Contract #: 04-0120F4Cty: SF/ALA Rte: 80 PM: 13.2/13.9File #: xx.25B

QUALITY ASSURANCE -- NON-CONFORMANCE REPORT

Location: Changxing Island, Shanghai, China**Report No:** NCR-000868**Prime Contractor:** American Bridge/Fluor Enterprises, a JV**Date:** 18-Oct-2010**Submitting Contractor:** Zhenhua Port Machinery Company, Ltd (ZPMC), Changxing Island**NCR #:** ZPMC-0830**Type of problem:**

Subject: NCR No. ZPMC-0830

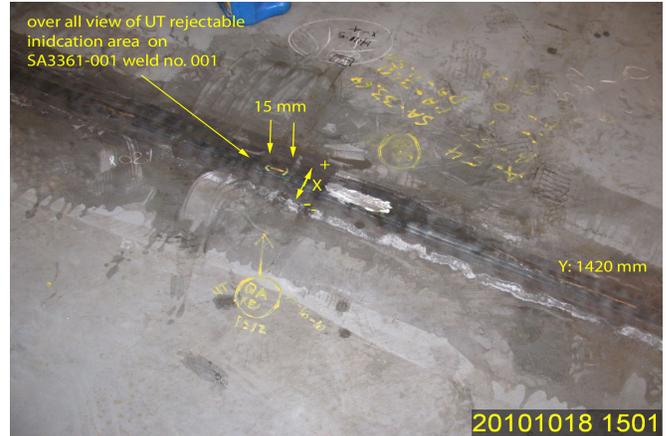
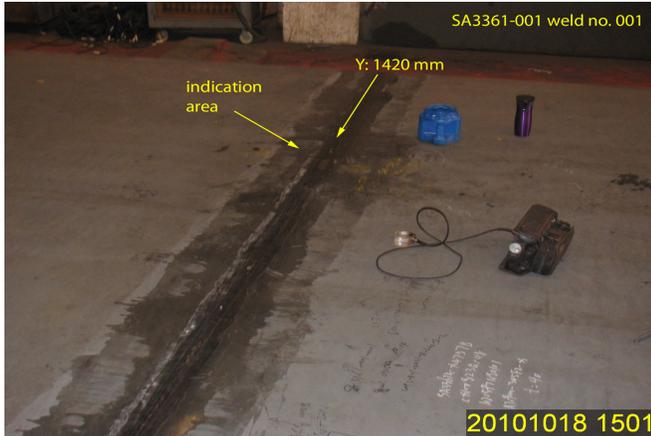
During the Quality Assurance Ultrasonic Testing (UT) review of welds located on OBG Sub Assembly SA3361-001 this Quality Assurance Inspector (QA) discovered the following issues:

- One ultrasonic longitudinal linear indication measuring approximately 15mm in length on a 40mm thick plate.
- The weld is identified as: SA3361-001-001.
- Indication rating is 0 dbs.
- Depth of indication is 12mm
- Y location is approximately 1420mm from the edge of the plate.
- The weld is a Complete Joint Penetration (CJP) joint, joining web plate X4757A to web plate X4757B.
- The OBG Sub assembly SA3161-001 is located in Bay 4 west side.

The NDT Inspection Notification Sheet is Document No. 07013. The indication is located within an area that has been previously tested and accepted by ZPMC Quality Control (QC) personnel. According to the contract documents, ZPMC's QC personnel are required to perform 100% UT inspection of this weld.

ZPMC acknowledged the indication was missed and has issued an internal NCR to address this problem. ZPMC has repaired the indication and is providing the NDT record to show the acceptance of this weld. Based on this, ZPMC is requesting closure of this NCR.

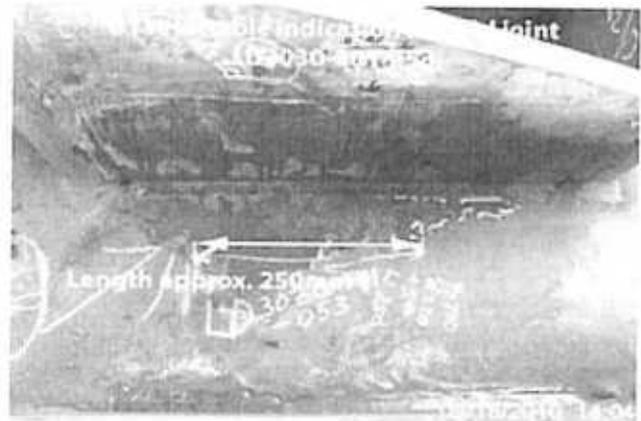
During the Quality Assurance (QA) Ultrasonic Testing (UT) review of welds located on Orthotropic Box Girder (OBG) segment 13BE and 13CE, this QA Inspector discovered the following issues:

- Three (3) longitudinal linear class "A" rejectable indications measuring approximately 180mm~260mm in length.
- The welds are identified as LD3028-001-031, LD3027-001-026 and LD3030-001-053.

- Material thickness for all joints is 30mm.
- The indication db rating for joint LD3028-001-031 is a +6.
- The indication db rating for joint LD3027-001-026 is a +4.

- The indication db rating for joint LD3030-001-053 is a +5.
- The depth of the indications are from 20mm~23mm deep.
- The Weld LD3028-001-031 is joining longitudinal diaphragm (X3682A) to lifting Lug.

- The Weld LD3027-001-026 is joining longitudinal diaphragm (X3684B) to lifting Lug.
- The Weld LD3030-001-053 is joining longitudinal diaphragm (X3685A) to lifting Lug.

- All Welds are Complete Joint Penetration (CJP) "T" joint.
- All welds are Seismic Performance Critical Members (SPCM).
- The Y distance for joint LD3028-001-031 is 110mm from bottom cope hole.

- The Y distance for joint LD3027-001-026 is 40mm from bottom cope hole.
- The Y distance for joint LD3030-001-053 is 700mm from bottom cope hole.
- The indications are clearly marked on or near the weld.

These welds were designated to be PJP welds and no UT is required. The NWIT were submitted due to the internal fault between the floor QC & NDT operator of ZPMC. ZPMC is providing the MT records to show the acceptance of these welds and is requesting closure of this NCR.

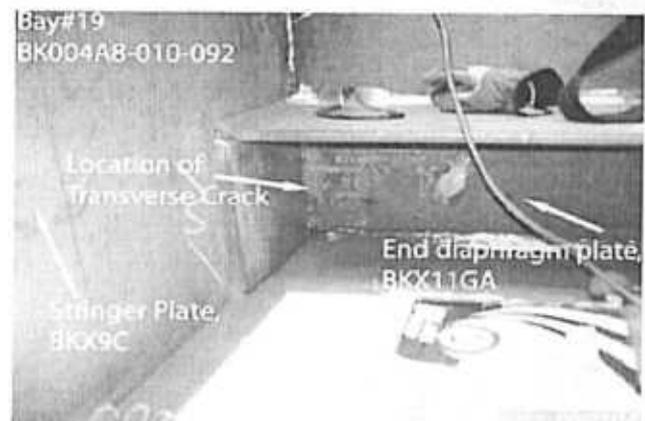
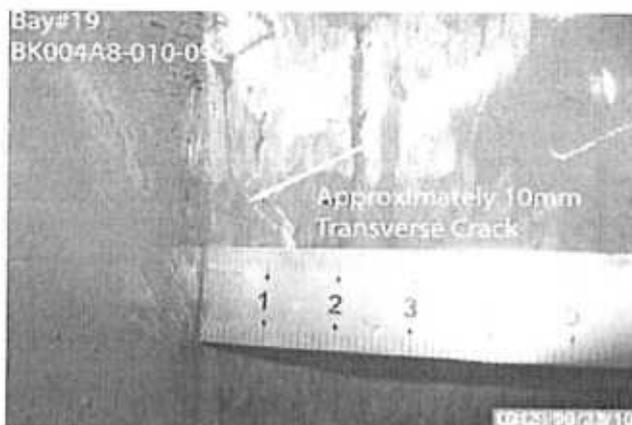
During the Quality Assurance (QA) Magnetic particle Testing (MT) review of welds located on OBG Bike path BK004A-010, this QA Inspector discovered the following issue:

- One transverse crack that measured approximately 10mm in length.
- The weld is identified as BK004A8-010-092.
- The weld is a Partial joint penetration (PJP) T joint, joining the Stringer plate (BKX9C) to the End diaphragm plate (BKX11GA).
- The Y Location is 100mm from the bearing plate.
- The OBG Bike path is located in BAY#19.
- This crack is clearly marked on the material on/near the weld.
- This weld joint is designated as Non-Seismic performance critical (Non-SPCM) weld member.
- The Notice of Witness Inspection Number (NWIT) is 006731.
- The crack is located within the area that has been re-tested and accepted by ZPMC Quality Control (QC) subsequent to the heat straightening procedure.

ZPMC acknowledged the indication was missed and has issued an internal NCR to address this problem. ZPMC has repaired the indication and is providing the NDT record to show the acceptance of this weld. Based on this, ZPMC is requesting closure of this NCR.

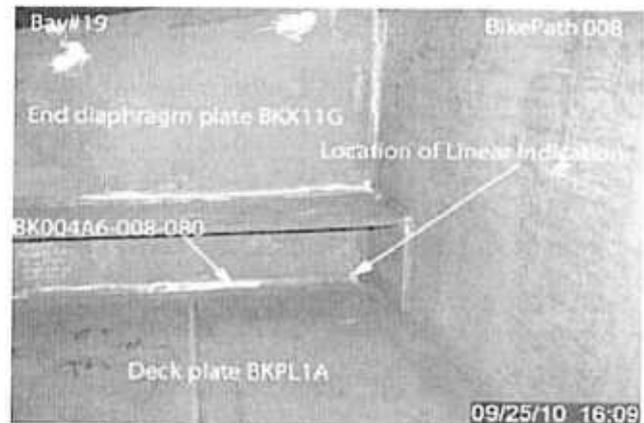
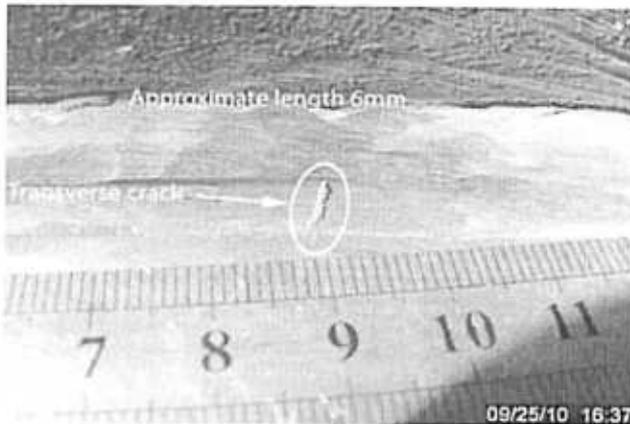
Quality Assurance (QA) Magnetic Particle Testing (MT) review of fillet welds located on OBG bike path BK004A-018, this QA Inspector discovered the following issues:

- One (1) transverse crack found on the weld measuring approximately 6mm in length.
- Y location of the indication is measured to be 2160mm.
- The crack is clearly marked on the weld joint.
- The weld is identified as: BK004A3-018-052.
- The Weld is a fillet weld joining the stringer plate (8C) to the deck plate of bike path.
- The member is located in bay 11.

The Notice of Witness Inspection Number (NWIT) is 06769. The indication is located within the area that has been previously tested and accepted by ZPMC Quality Control (QC) personnel.

ZPMC acknowledged the indications were missed and has issued an internal NCR to address this problem. ZPMC has repaired the indications and is providing the NDT records to show the acceptance of the welds. Based on this, ZPMC is requesting closure of this NCR.

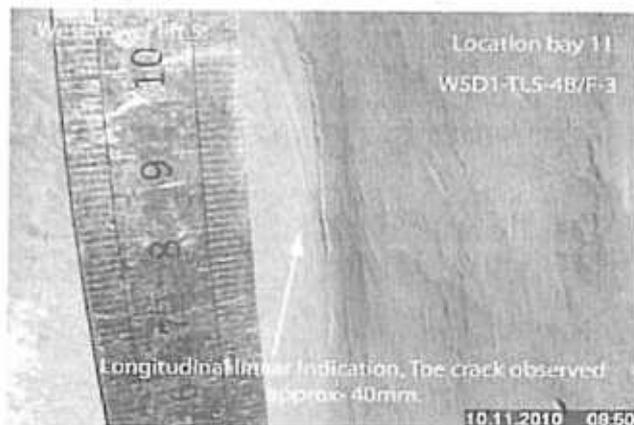
During the Quality Assurance (QA) Magnetic Particle Testing (MT) review of welds located in West Tower lift 5 Grillage plate, WSD1-TL5-4B/F-3, this Quality Assurance (QA) Inspector discovered the following issues:

-One longitudinal toe crack measuring approximately 40mm in length.

-The weld is identified as: WSD1-TL5-4B/F-3.

-The Weld is a Complete Joint Penetration (CJP) weld, joining the grillage plate to skin plate.

-The Notice of Witness Inspection Number (NWIT) is 06917. The indication is located on CJP weld area that has been previously tested and accepted by ZPMC Quality Control (QC) personnel. As per the contract documents, ZPMC's QC personnel are required to perform 100% MT inspection of this weld. The attached photographs provide additional detail.

ZPMC acknowledged the indication was missed and has issued an internal NCR to address this problem. ZPMC has repaired the indication and is providing the NDT record to show the acceptance of this weld. Based on this, ZPMC is requesting closure of this NCR.

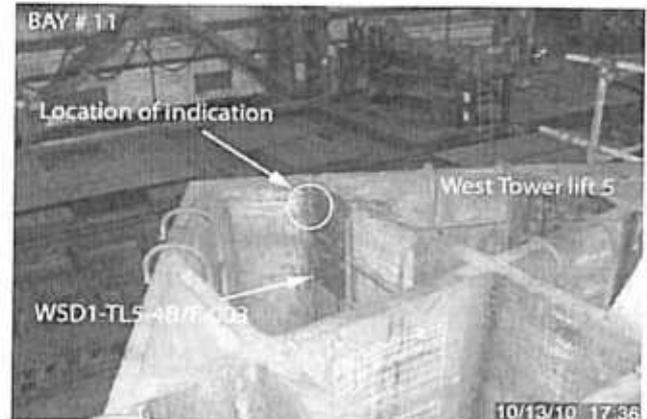
During the Quality Assurance Ultrasonic Testing (UT) verification of welds located on grillage plate of West Tower lift 5, this Quality Assurance (QA) Inspector discovered the following issues:

- One class "A" longitudinal indication measuring approximately 50mm in length.
- The depth of the indication is 57mm.
- The db rating is -2.
- The material thickness is 65mm.
- The weld is identified as: WSD1-TL5-4B/F-003.
- The Weld is a Complete Joint Penetration (CJP) with steel backing, T-joint, joining the grillage plate to the skin plate (skin "D").
- The "Y" location of the indication is 110mm from top side
- The indication is clearly marked on the component.
- The member is located in Bay 11.

The Notice of Witness Inspection Number (NWIT) is 06938. The indication is located inside the area that has been previously tested and accepted by ZPMC Quality Control (QC) personnel. As per the contract documents, ZPMC's QC personnel are required to perform 100% UT inspection of this weld.

-Attached photographs provide additional location details.

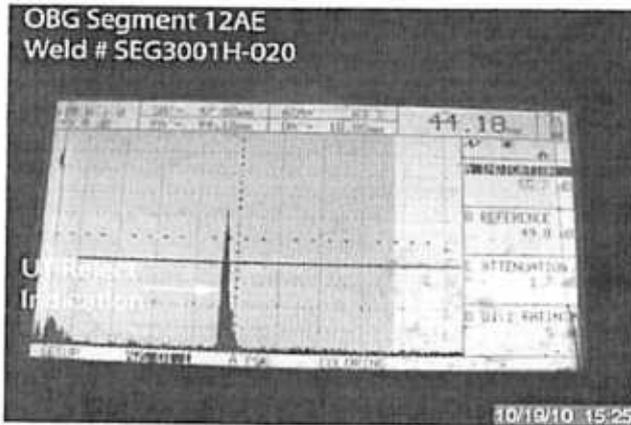
During the Quality Assurance (QA) Ultrasonic Testing (UT) verification of weld located on Segment 12AE, this QA Inspector discovered the following issue:
